Re: Dodgeville Public Library Addition and Renovation  
HGA Add Services Proposal 03 – Existing Precast Plank Repairs Engineering Services  
HGA Commission Number: 3757-004-00

**EXISTING  
OPENINGS IN  
PRECAST  
PLANK**

S210

1 EXISTING OPENINGS IN PRECAST PLANK  
3/16" = 1'-0"

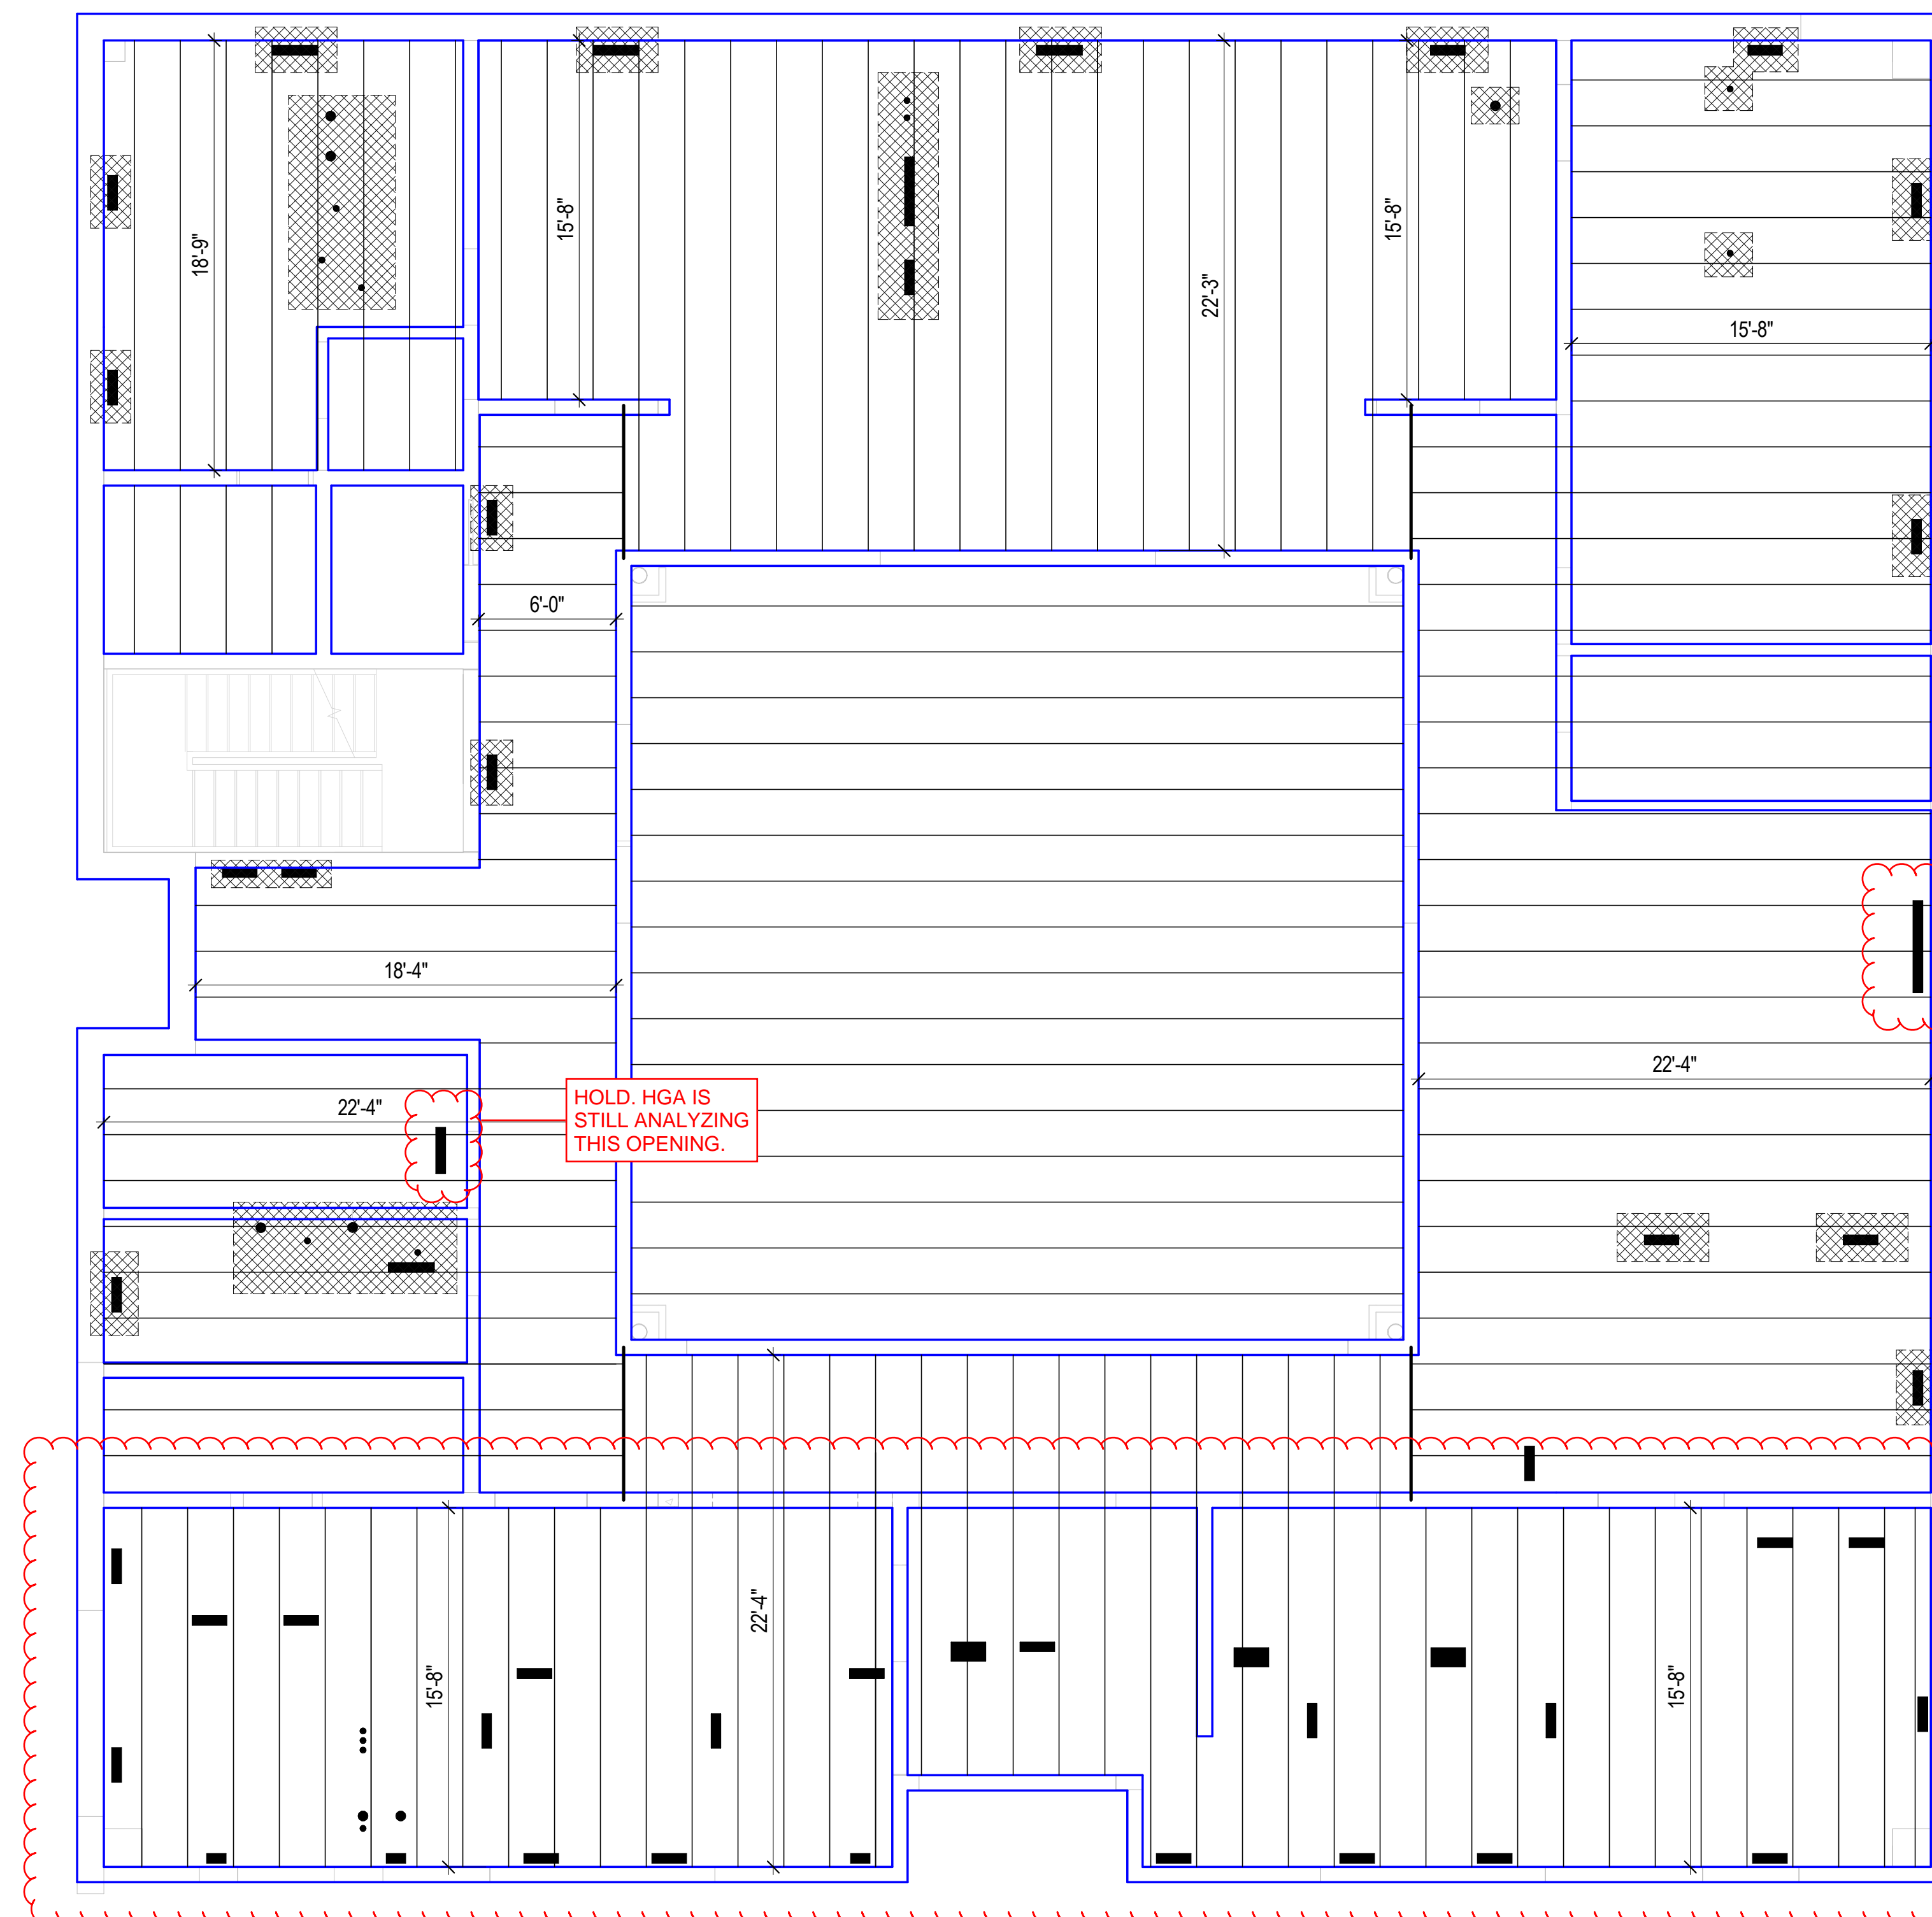
1. OPENINGS IN EXISTING PRECAST PLANK ARE SHOWN BY [REDACTED].
2. LAYOUT OF EXISTING PRECAST PLANK IS APPROXIMATE. VERIFY IN FIELD.
3. SIZE AND LOCATION OF EXISTING OPENINGS ARE APPROXIMATE. VERIFY IN FIELD.
4. OPENINGS IDENTIFIED BY [REDACTED] REQUIRE NO STRUCTURAL MODIFICATIONS AND CAN BE INFILLED USING DETAIL 2/2S10 (OR LEFT OPEN IF THEY ARE BEING USED FOR CURRENT MEP PIPING OR CONDUITS).

HOLD. HGA IS STILL ANALYZING THIS OPENING.

HOLD. HGA IS STILL ANALYZING THESE OPENINGS.

PARTIAL PLAN VIEW

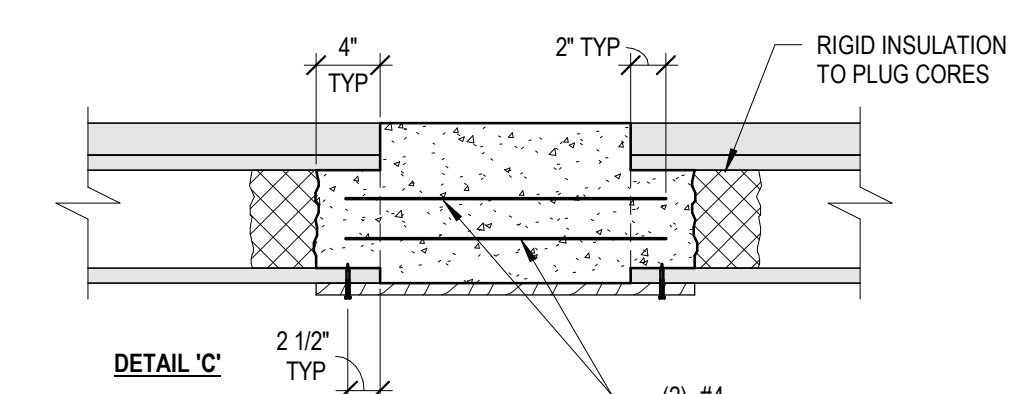
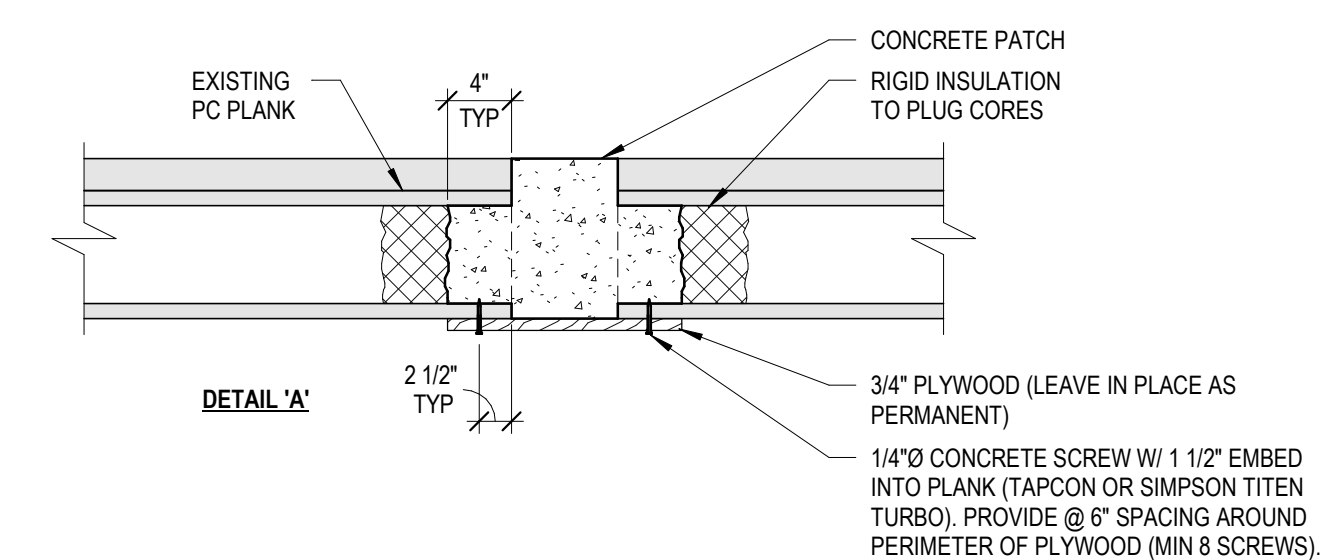
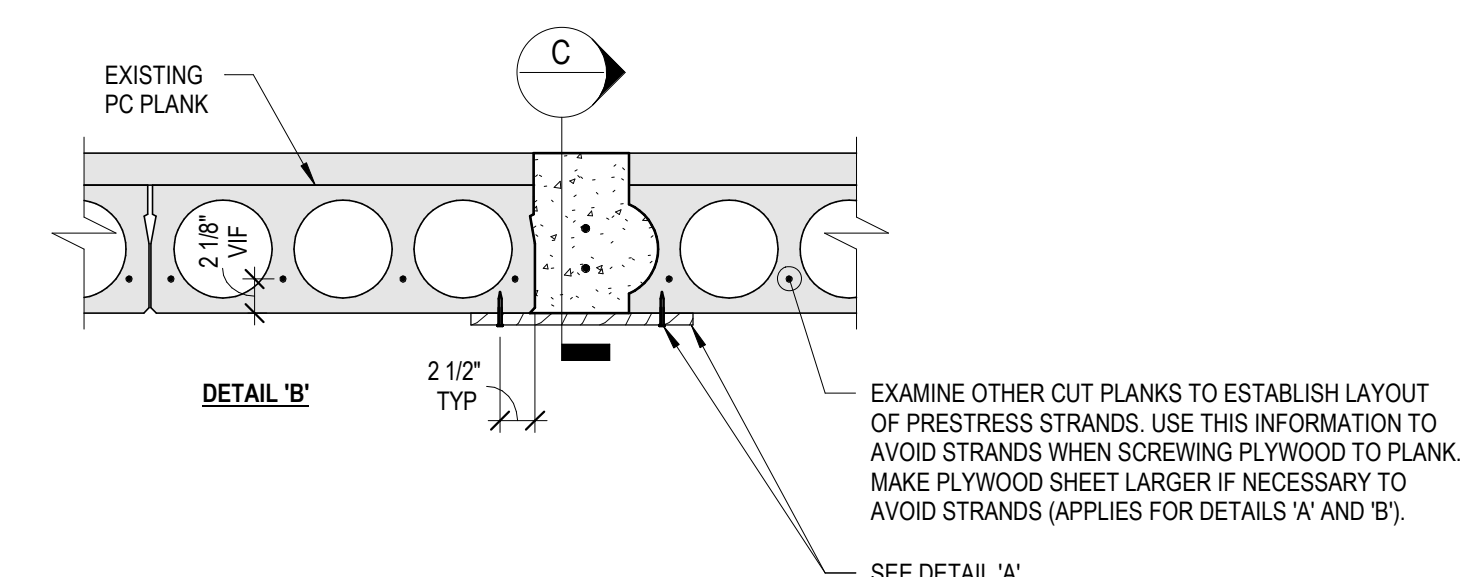
EXAMINE OTHER CUT PLANKS TO ESTABLISH LAYOUT OF PRESTRESS STRANDS. USE THIS INFORMATION TO AVOID STRANDS WHEN SCREWING PLYWOOD TO PLANK. MAKE PLYWOOD SHEET LARGER IF NECESSARY TO AVOID STRANDS (APPLIES FOR DETAILS 'A' AND 'B').
